re: Geotechnical Slope Stability Review
Rideau Carleton Raceway
4837 Albion Road - Ottawa

date: April 23, 2020

file: PG4315-MEMO.04 Revision 1

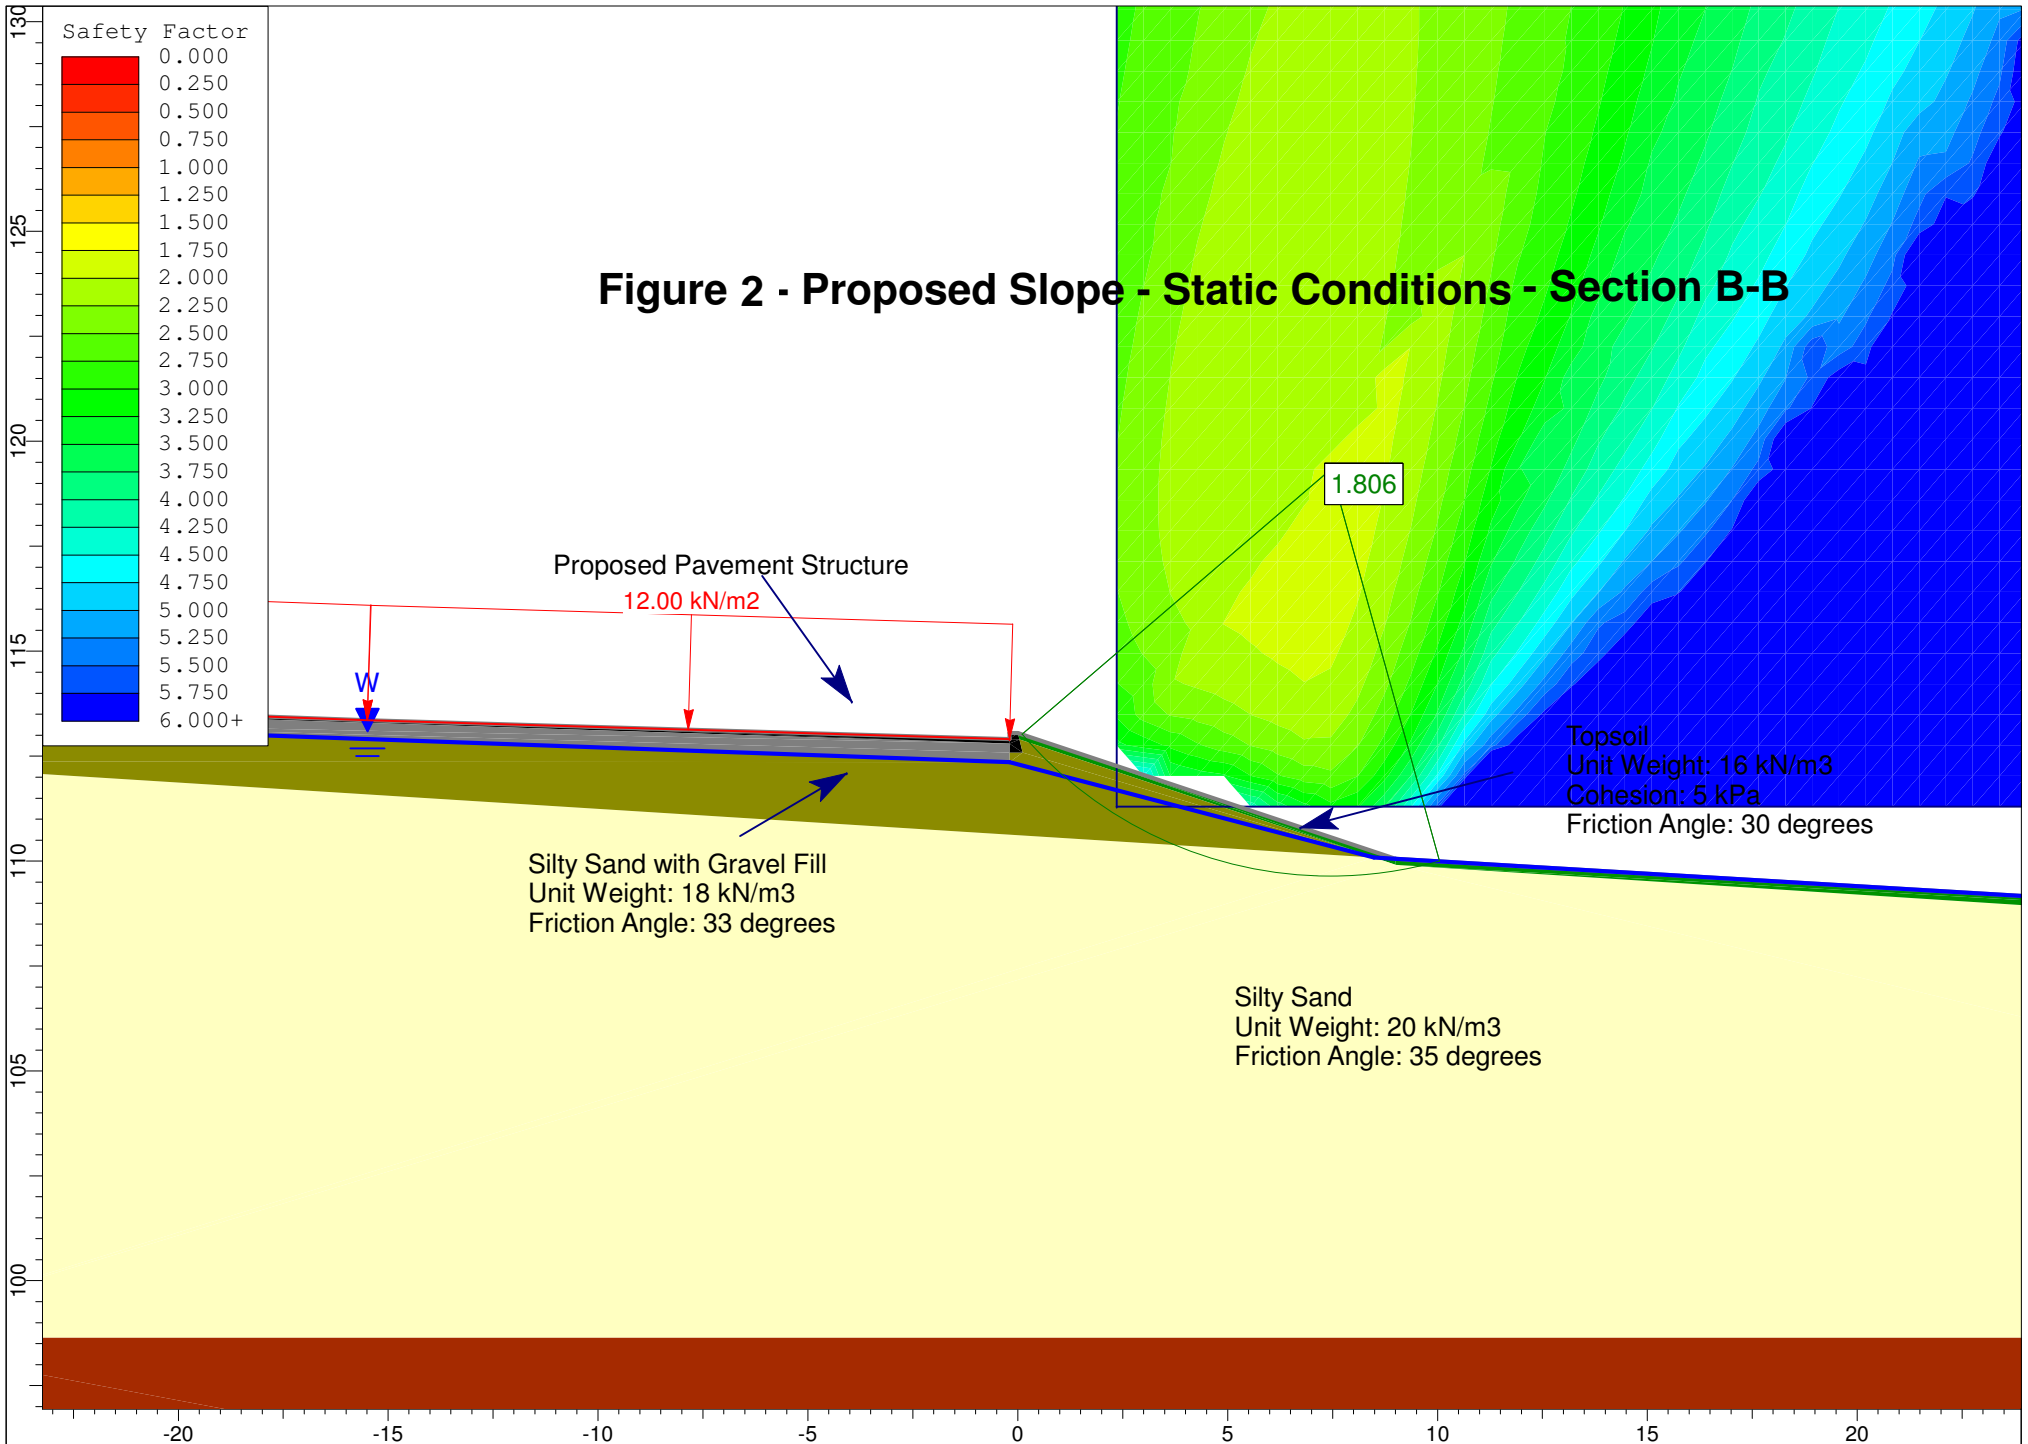
The results of the static loading analyses for the cross-section is shown in Figure 2. The minimum slope stability factor of safety was calculated to exceed the minimum recommended factor of safety of 1.5 for static conditions. Based on the results, the proposed slope is considered stable under static loading.

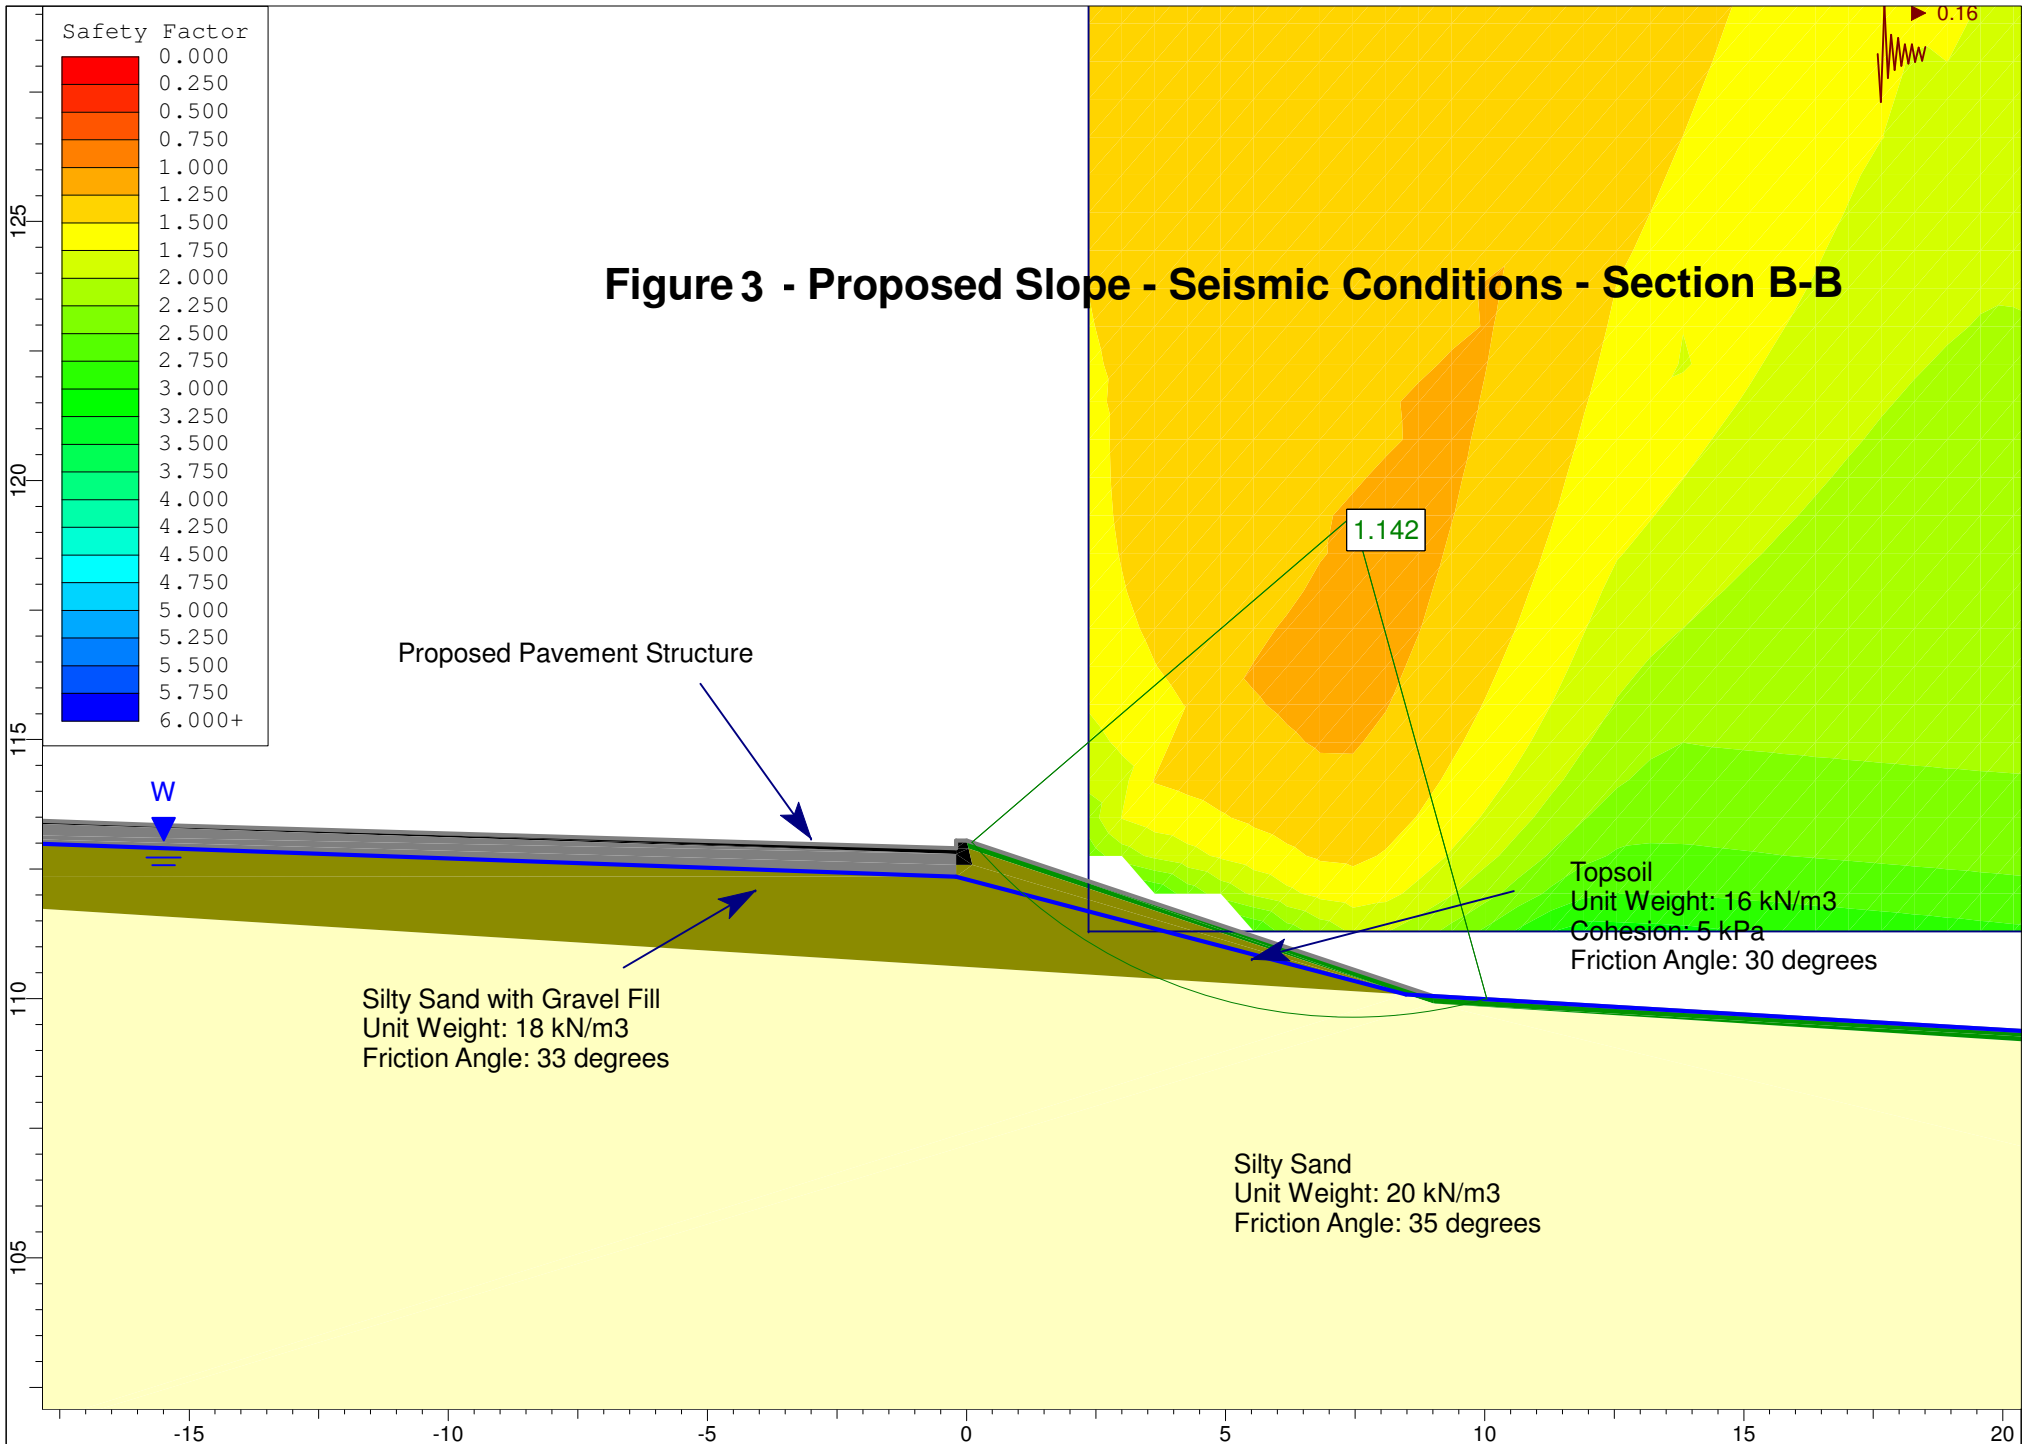
The result of the analysis including seismic loading is shown in Figure 3. The overall slope stability factor of safety for the subject section considering seismic loading was found to be greater than 1.1. Based on the results, the slope is considered stable under seismic loading.

DRAWING NO.
116111-GR4

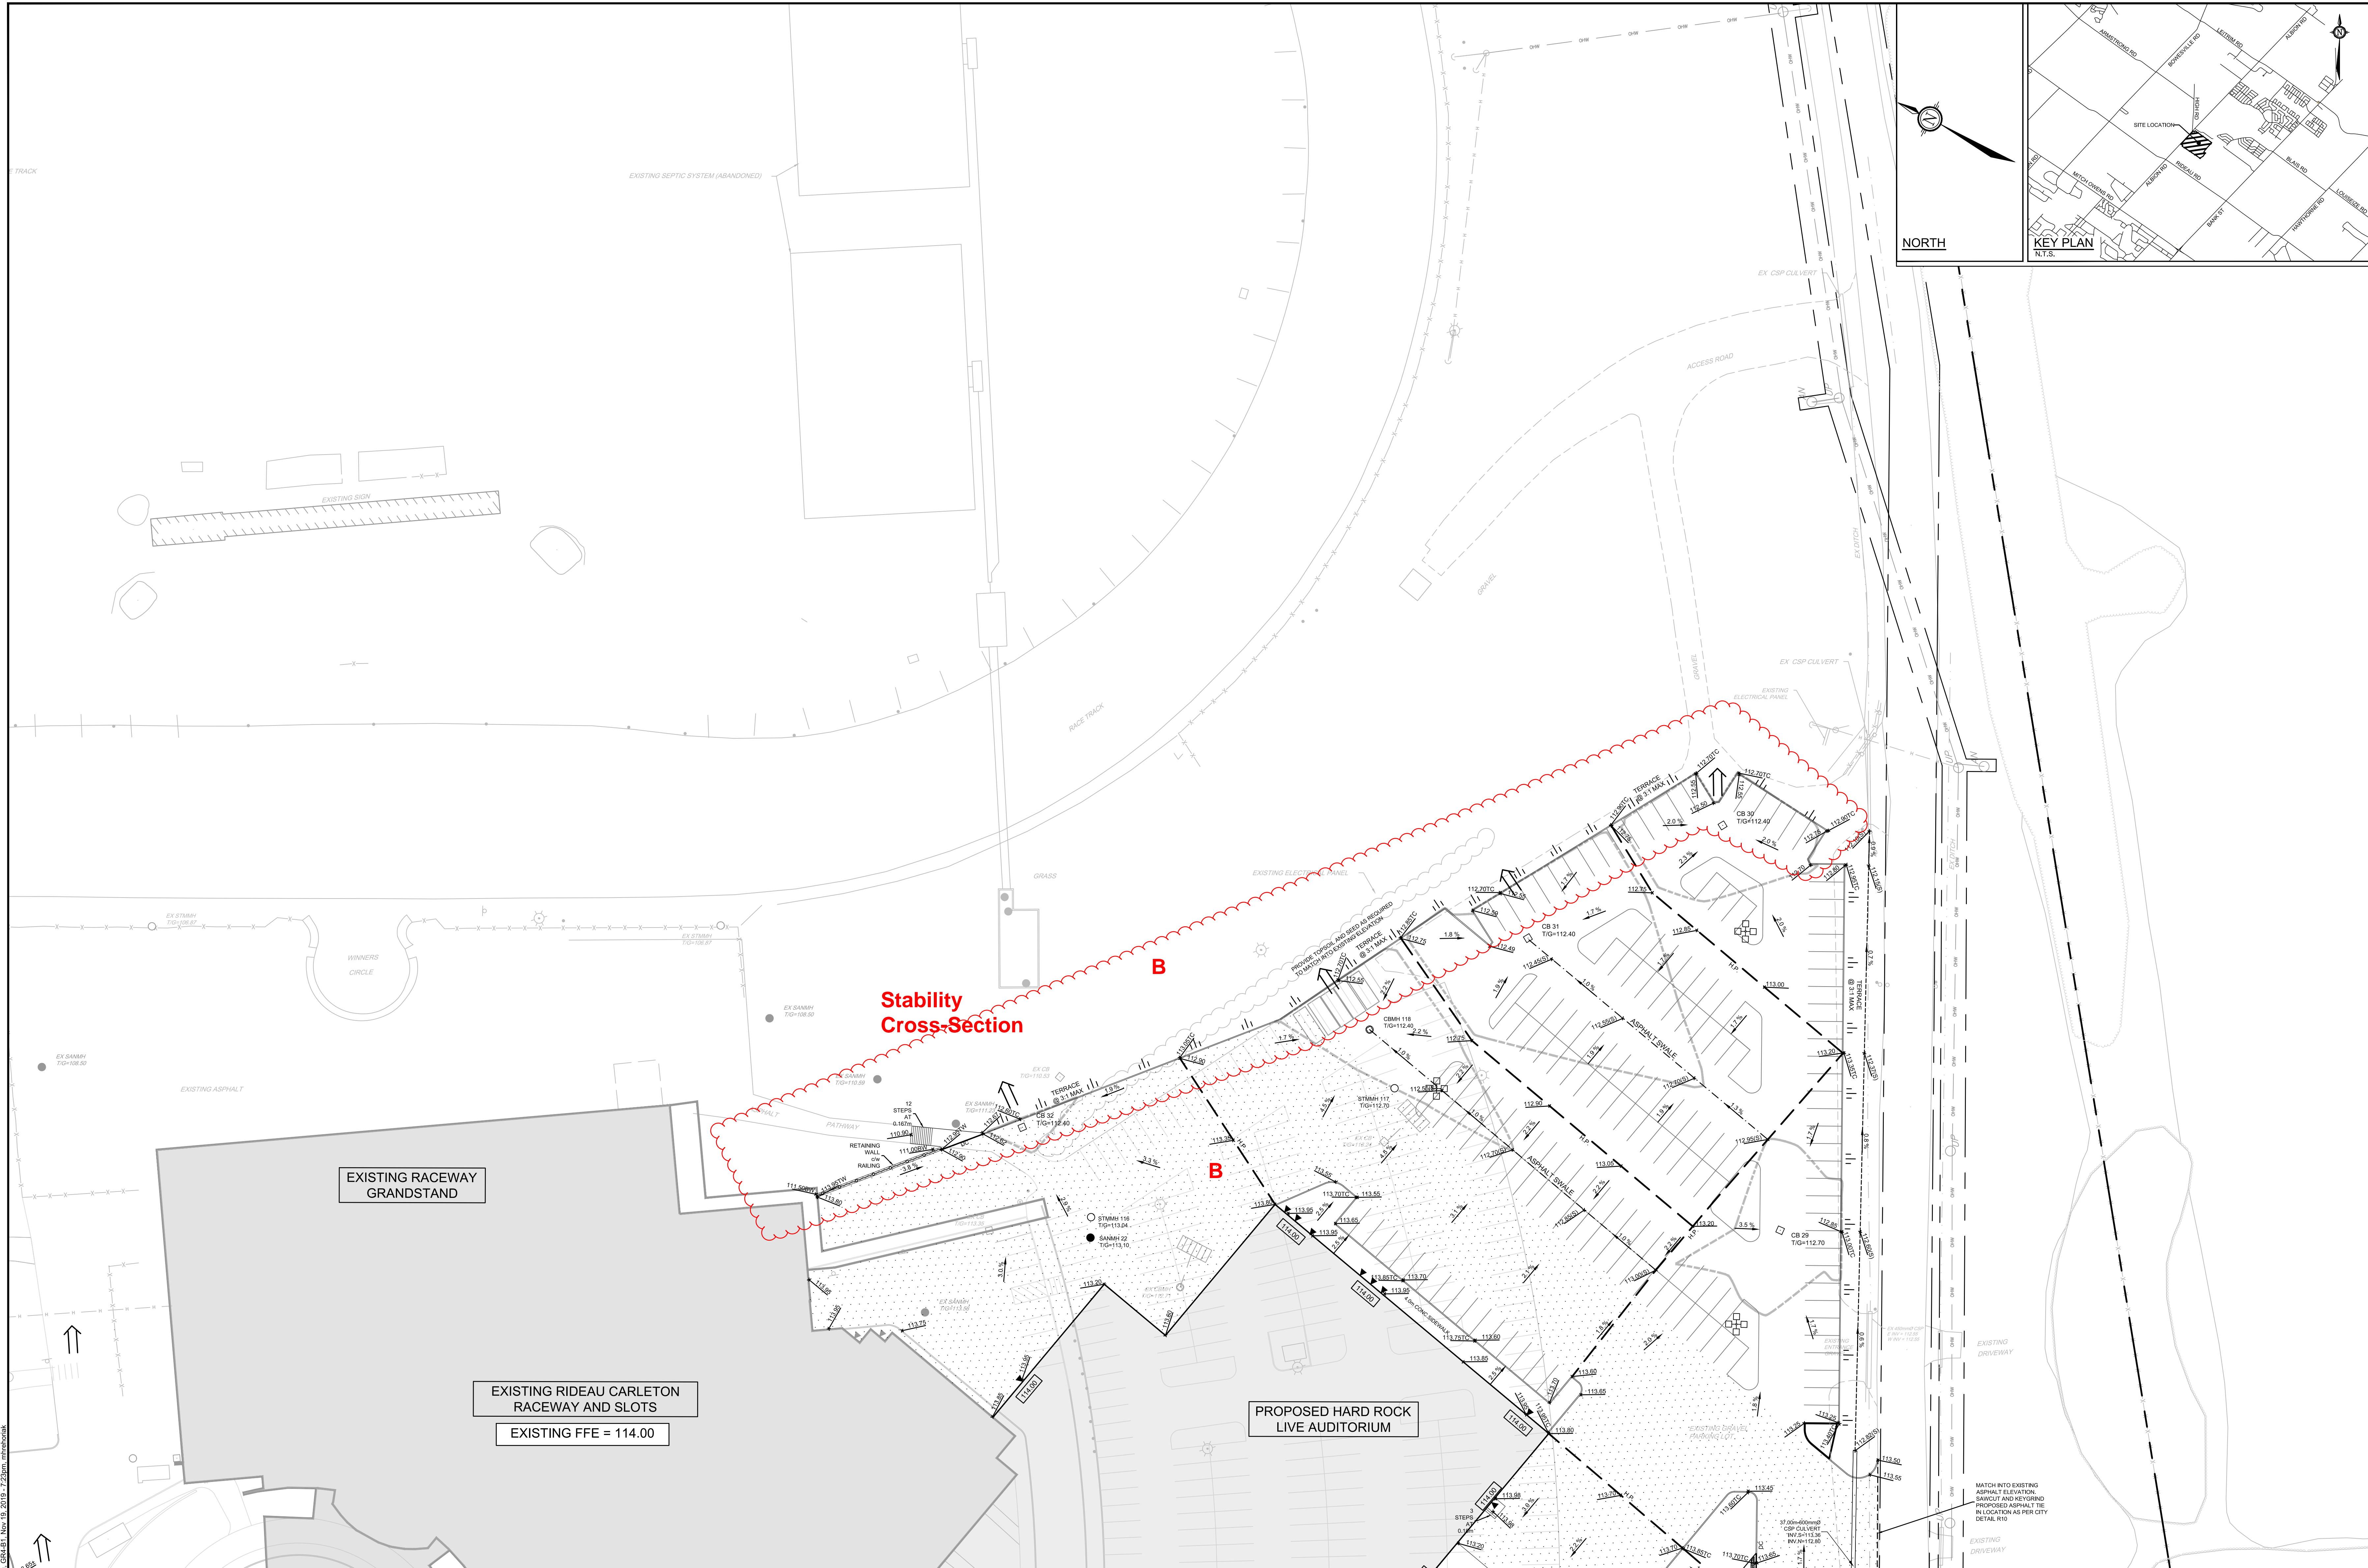
Based on our review of the above noted plan, a maximum slope height of 1.5 m is required to match existing grades. Based on the space available, it is expected that a maximum 3H:1V slope profile will be used to shape the slopes required to meet existing grades.

A single section (Section B-B) of the slope was analysed since the slope is to be consistent throughout the entire north portion of the site. The location of the cross-section is presented on Drawing GR-4 - Grading Plan North attached to the current report.

From a geotechnical perspective a 3H:1V slope is considered stable. It is recommended that the slope face be protected during construction against surficial erosion until vegetation is established. A minimum layer of 100 mm of topsoil is recommended. The topsoil should be covered with an erosion control blanket and hardy grass seeds should be used to establish vegetation.
